AT89C51RD2/ED2

Silicon Errata and Data Sheet Clarifications

3.3.1 44-Lead TQFP (PT)

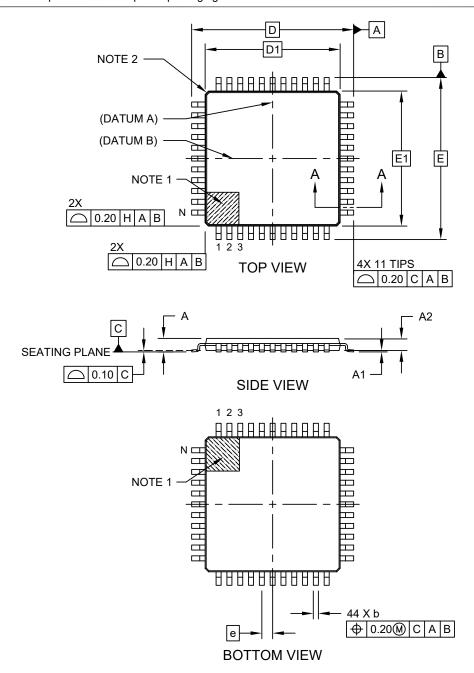
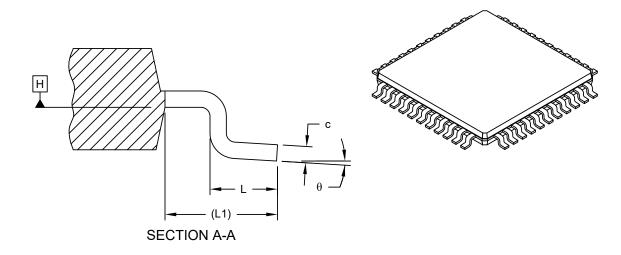
A clarification has been made to replace the VQFP package with a TQFP package.

A drop-in replaceable 44-lead TQFP with the same pinout, footprint, and based on the same die revision replaces the 44-lead VQFP package. There are no functional changes, hence all data sheet specifications are still valid for the replacement CPNs.

The TQFP package outline drawing is shown below.
